ADDENDUM NO. 1

PROJECT TITLE:
**REPLACEMENT OF BRIDGE NO. 05585 - INTERSTATE 91
OVER GRAPE BROOK**

PROJECT NO.:
0048-0200

DRAWING TITLE:
LAYOUT PLAN

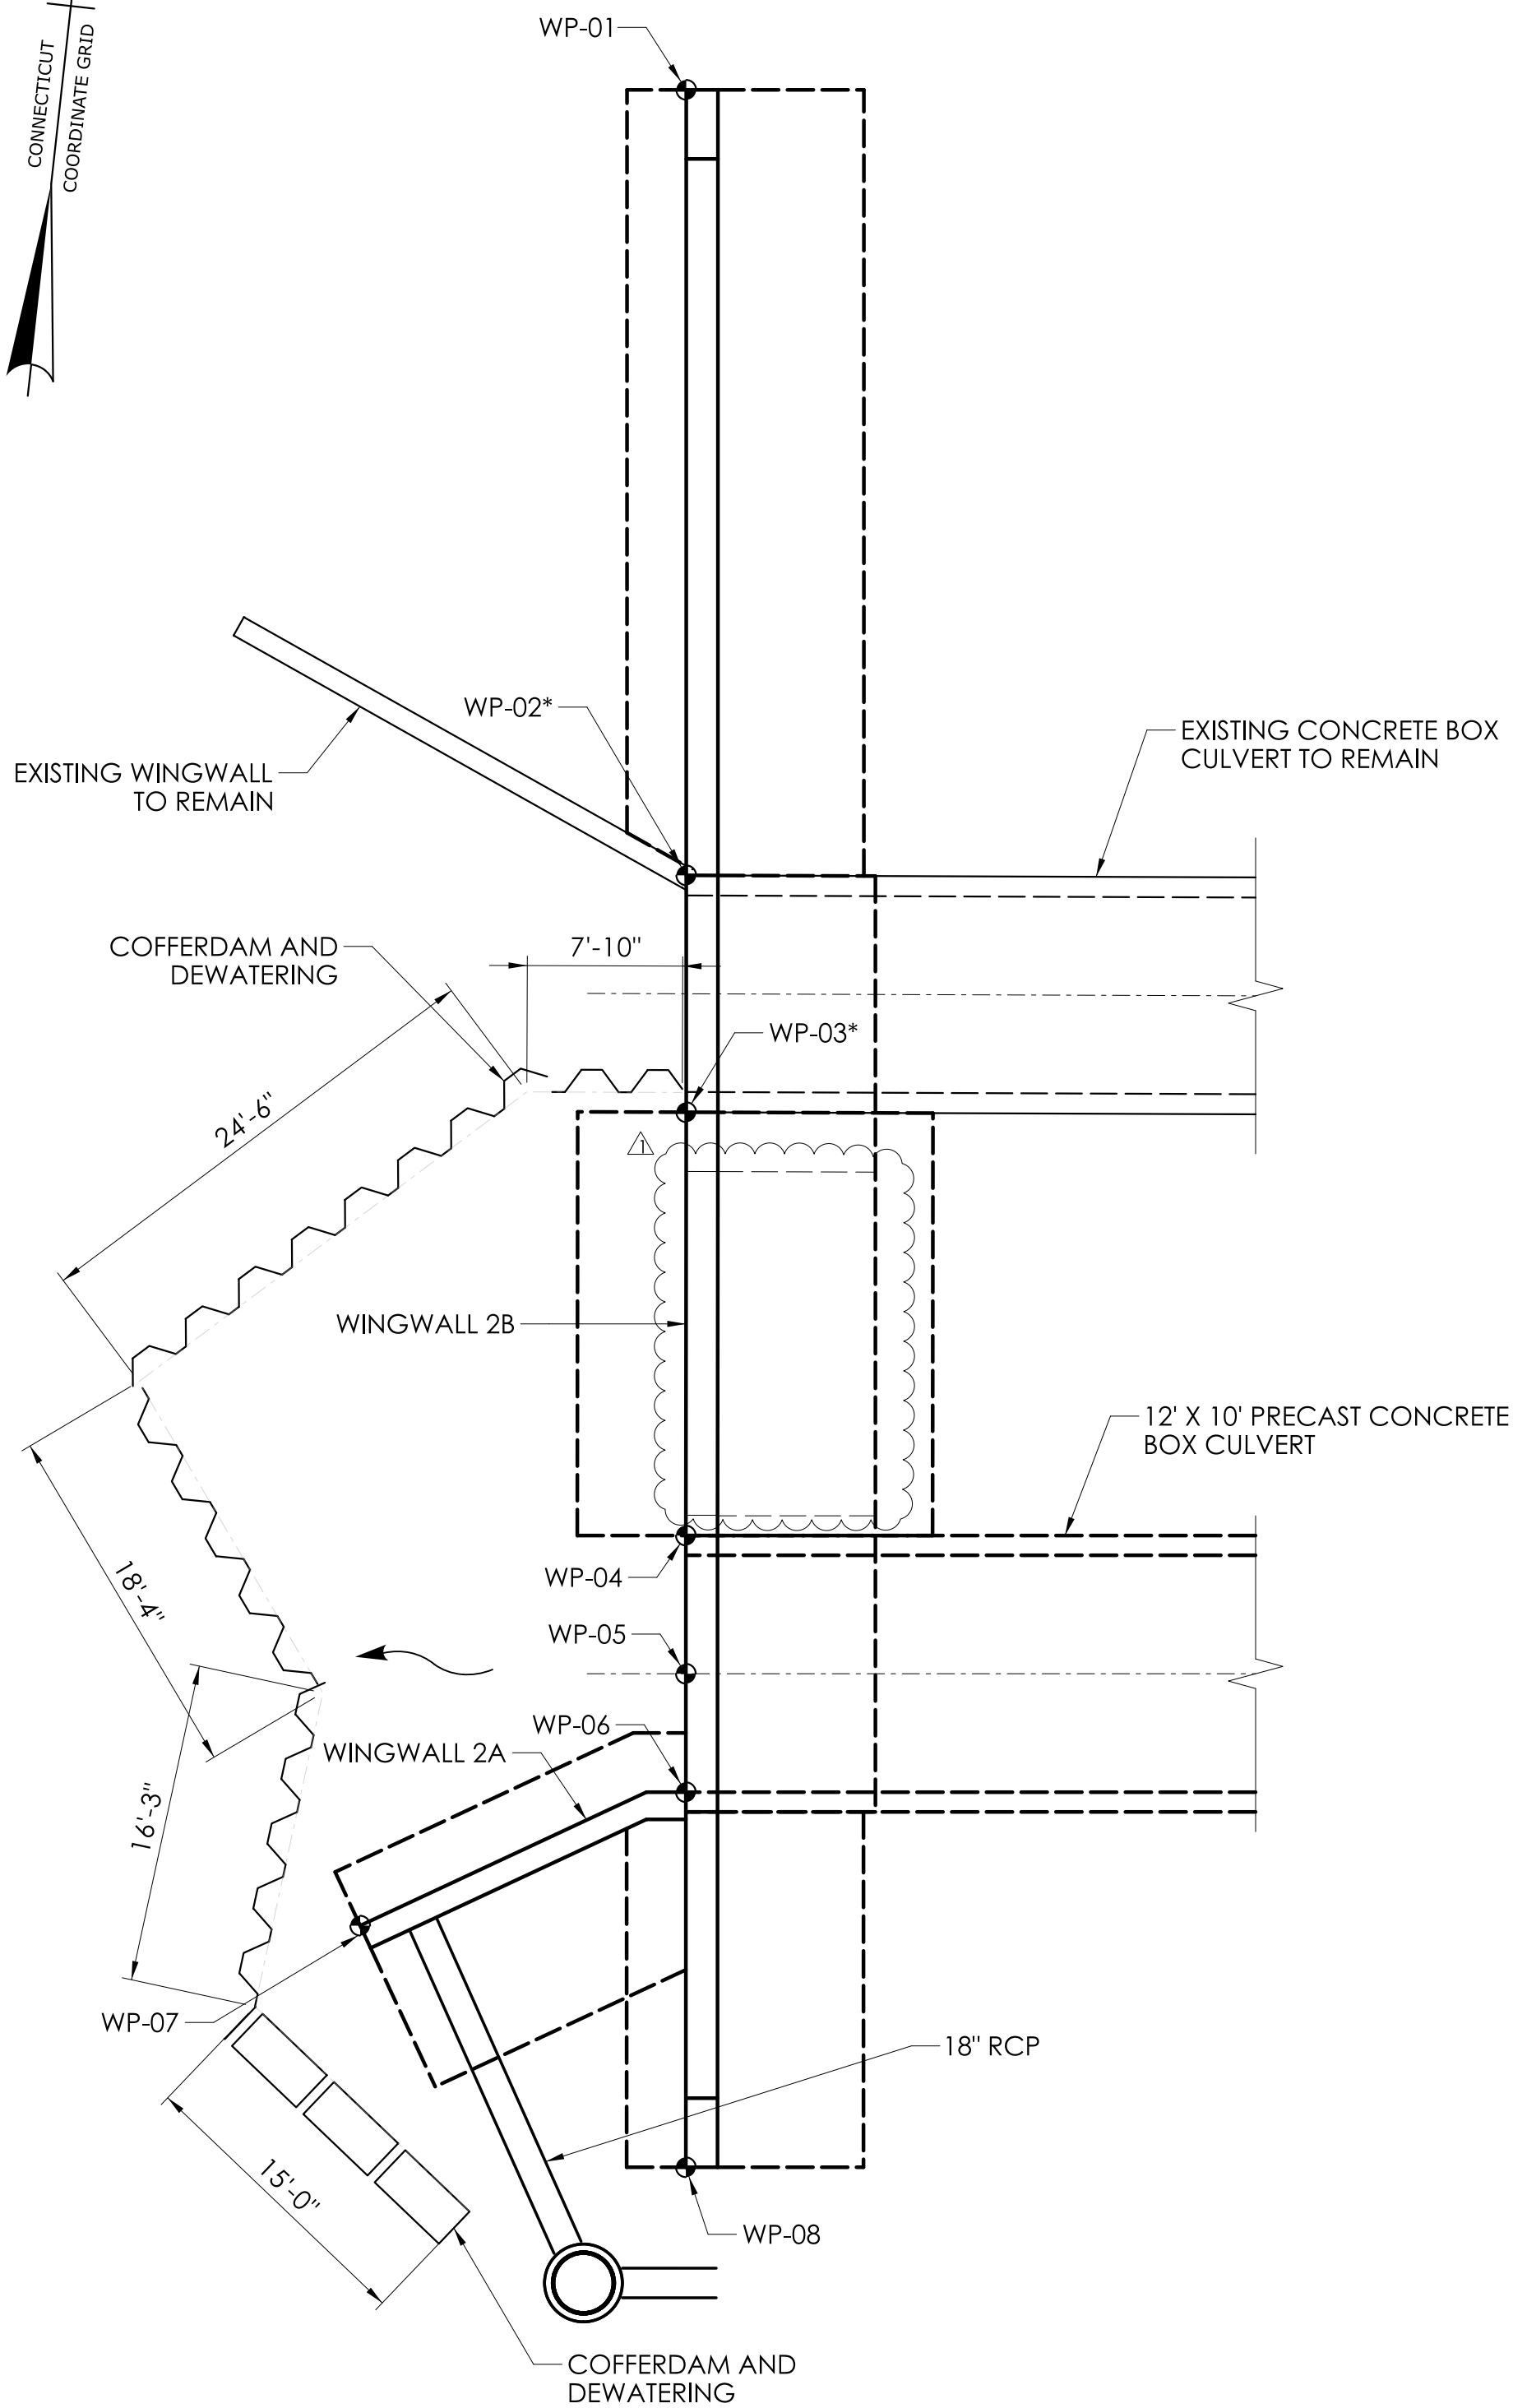
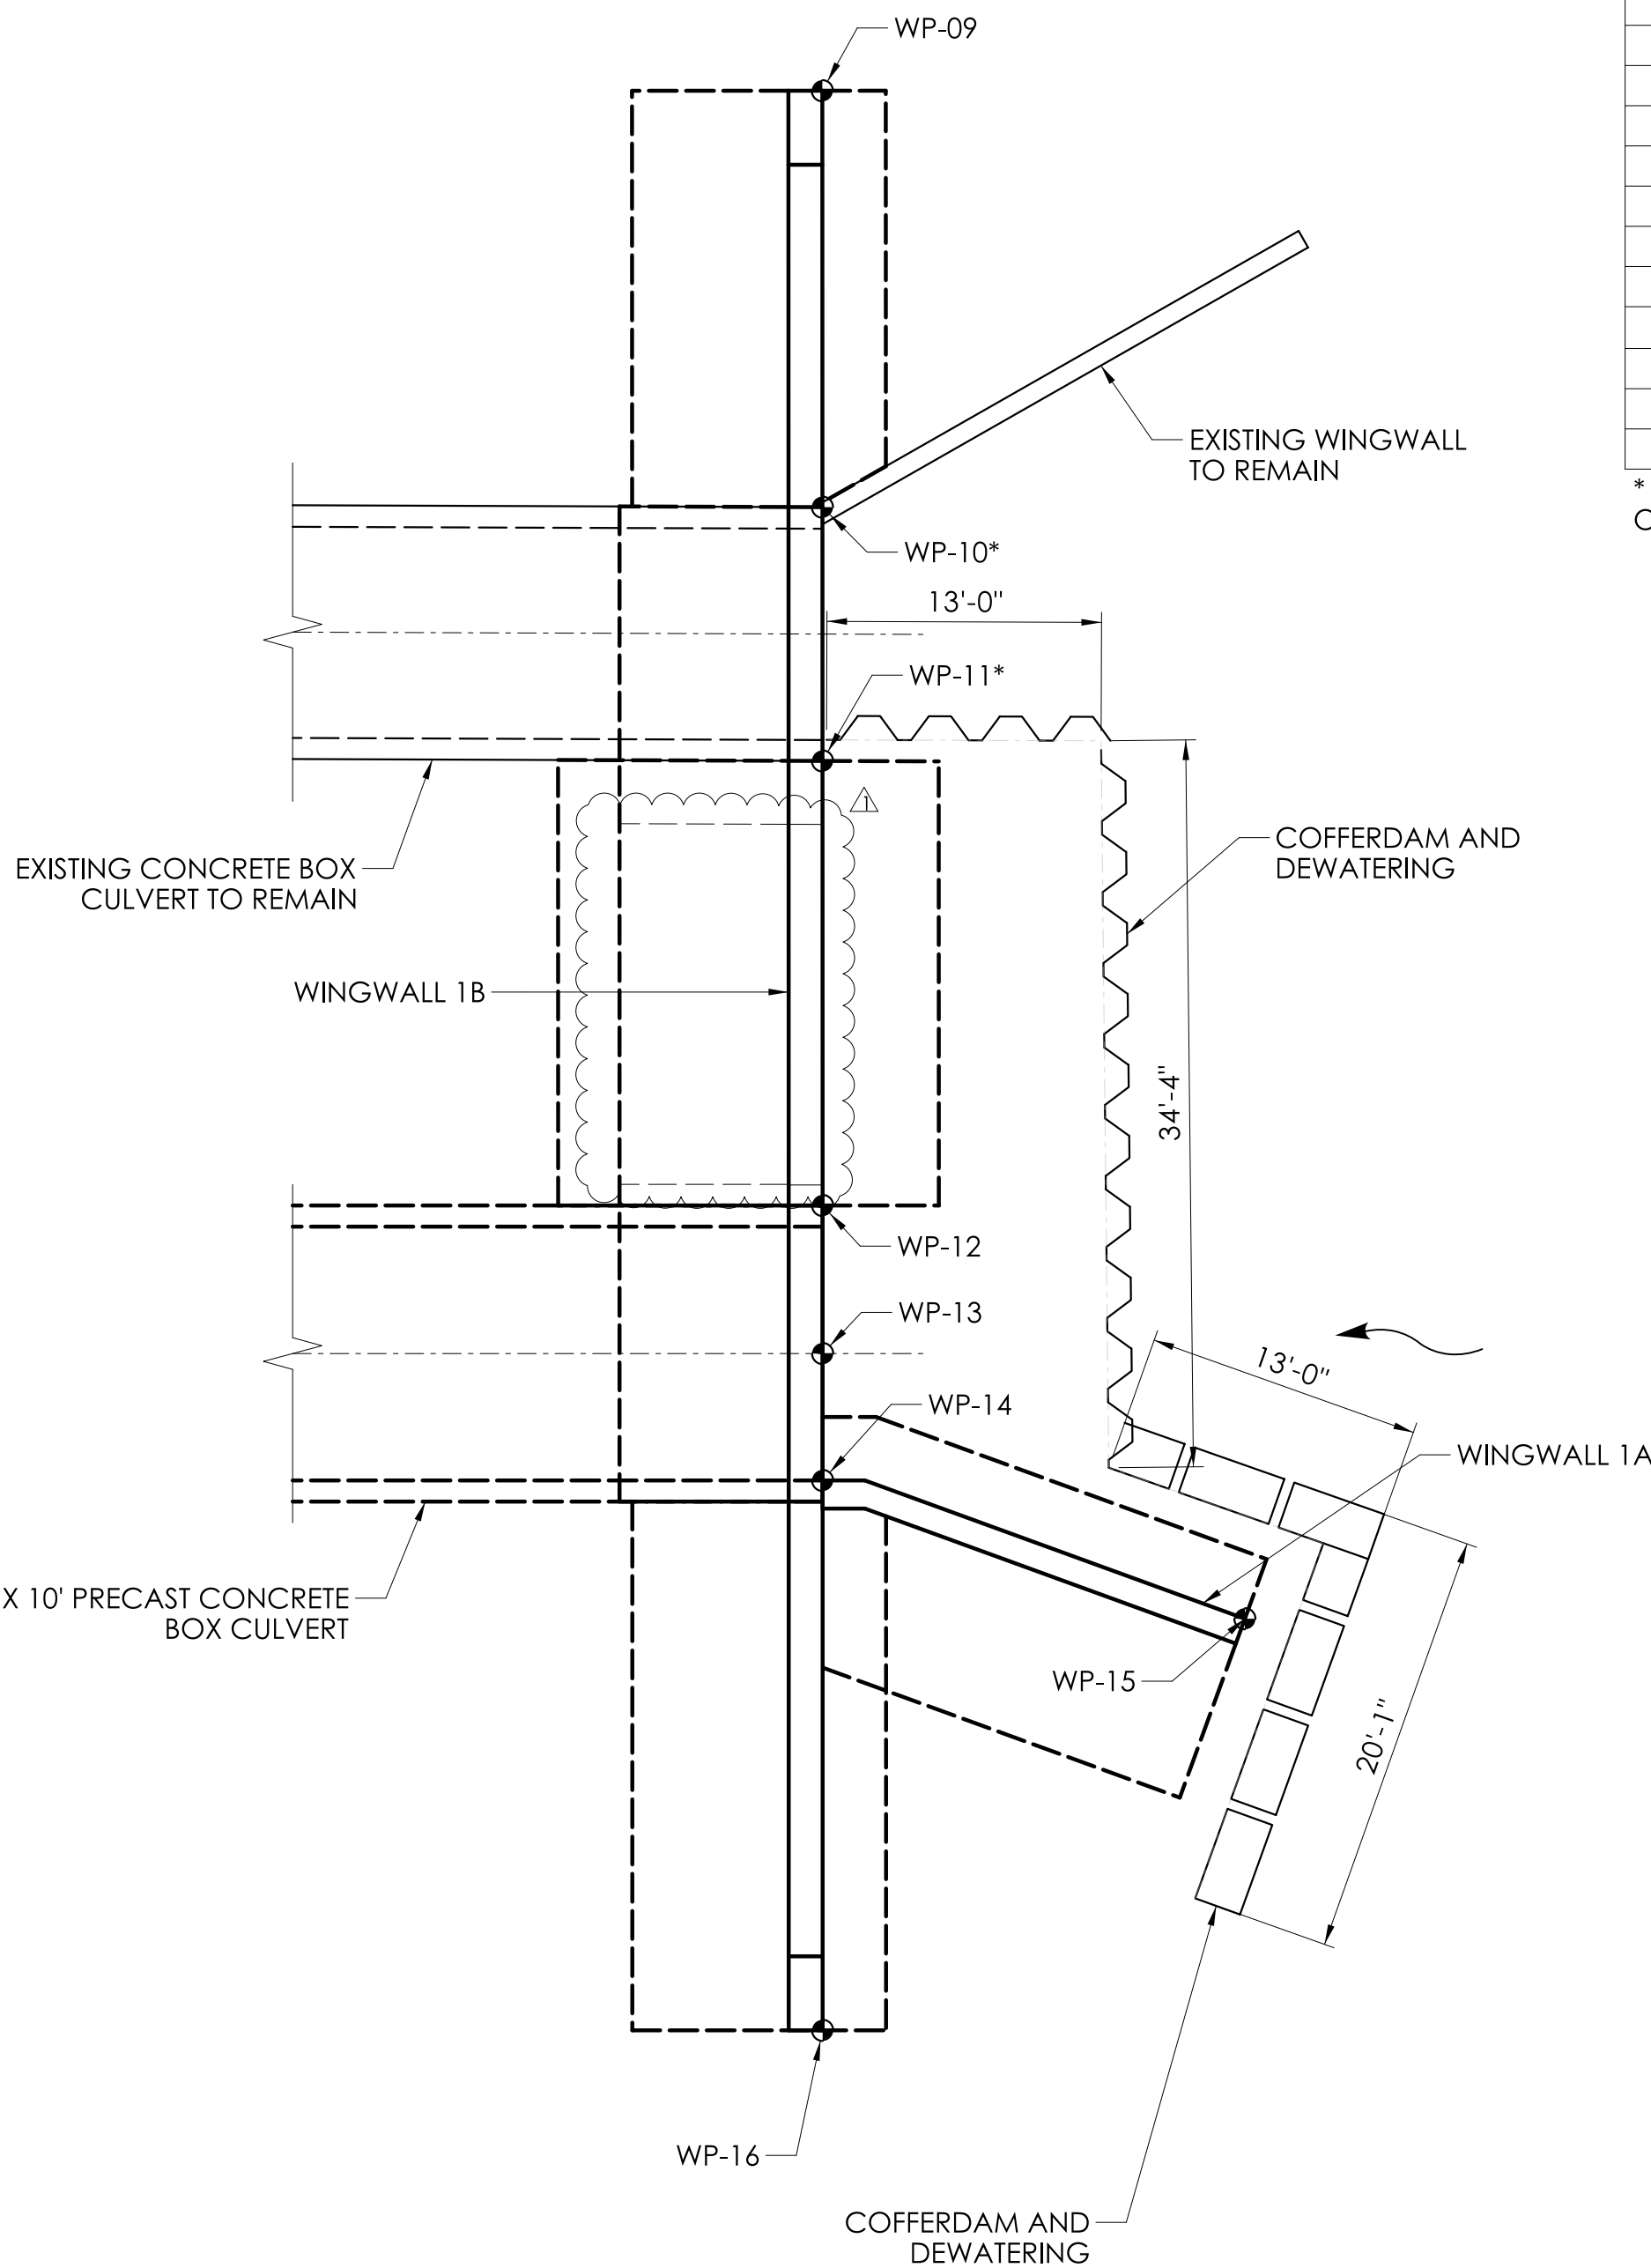
REV	DATE	REVISION DESCRIPTION
1	09/12/25	REVISED JOINT LOCATIONS
